Development Special Use Permit #2017-0015 Coordinated Development District Concept Plan #2017-0002 Special Use Permit #2017-0092, Encroachment #2017-0003 Transportation Management Plan SUP #2017-0097 200 Stovall Street - Hoffman Town Center Block 6A

Applicant	General Data		
Project Name: Hoffman Town Center, Block 6A Location: 200 Stovall Street	PC Hearing:	September 7, 2017	
	CC Hearing:	September 16, 2017	
	If approved, DSUP Expiration:	N/A*	
	Plan Acreage:	1.5 acres (65,161 sq. ft.)	
	Zone:	CDD #2	
Applicant: Perseus Realty, LLC	Proposed Use:	Residential and Retail	
	Gross Floor Area:	Residential: 594,108 sf	
		Retail: 36,475 sf	
	Small Area Plan:	Eisenhower East	
	Green Building:	LEED Certified for residential; requesting flexibility for retail

# Staff Recommendation: APPROVAL WITH CONDITIONS

# ENCROACHMENTS ALONG SWAMPFOX ROAD

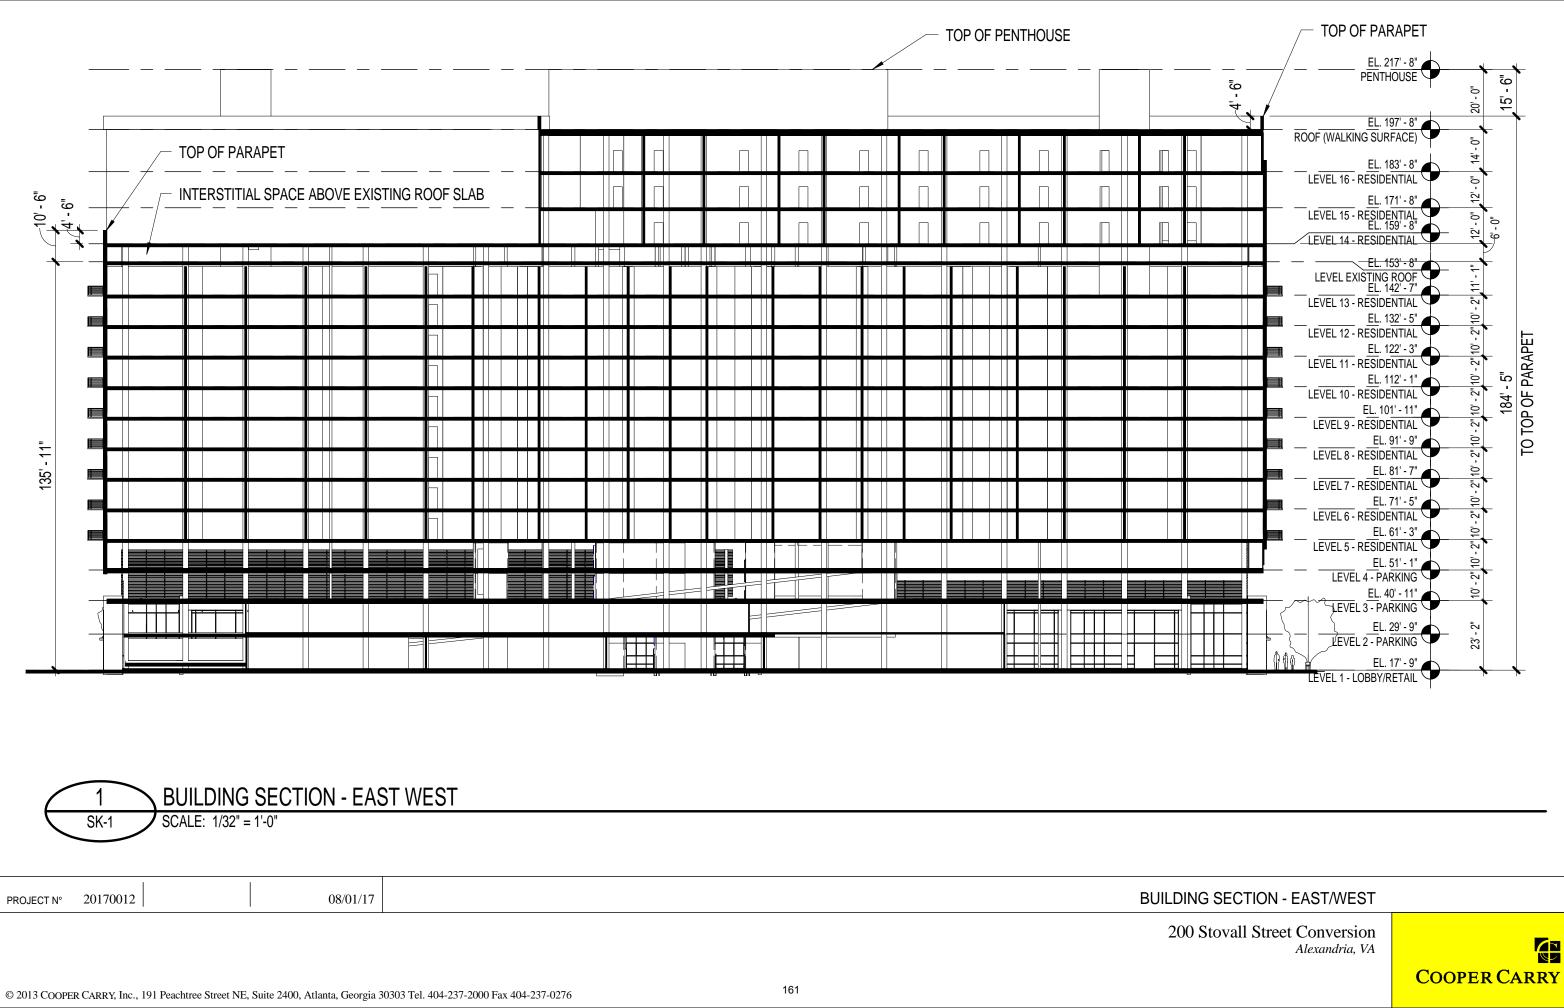
- An Encroachment (ENC2017-0003); A request for residential balconies to extend 3'-6" into the public right-of-way on Swamp Fox Road.
- A Transportation Management Plan Special Use Permit Amendment to TMP SUP1998-0043; A minor amendment to previously approved TMP SUP#1998-0043 to amend Condition #9 to update the commercial use rate, and include residential and retail uses and their associated rates.

The applicant proposes apartment units on floors five through sixteen of the building. In order to promote the marketability of the units, and to provide a variety of options to the tenants, two kinds of residential balconies are offered: (1) Balconies that are flush with the face of the building, located on the north and south facades, and (2) Balconies that protrude from the face of the building, located on the east and west facades. On the east façade, which faces Swamp Fox Road, the property line is located approximately 1'-9" from the face of the building. For this reason, the applicant requests an Encroachment for the residential balconies of 3'-6" into the public right of way at this location only.
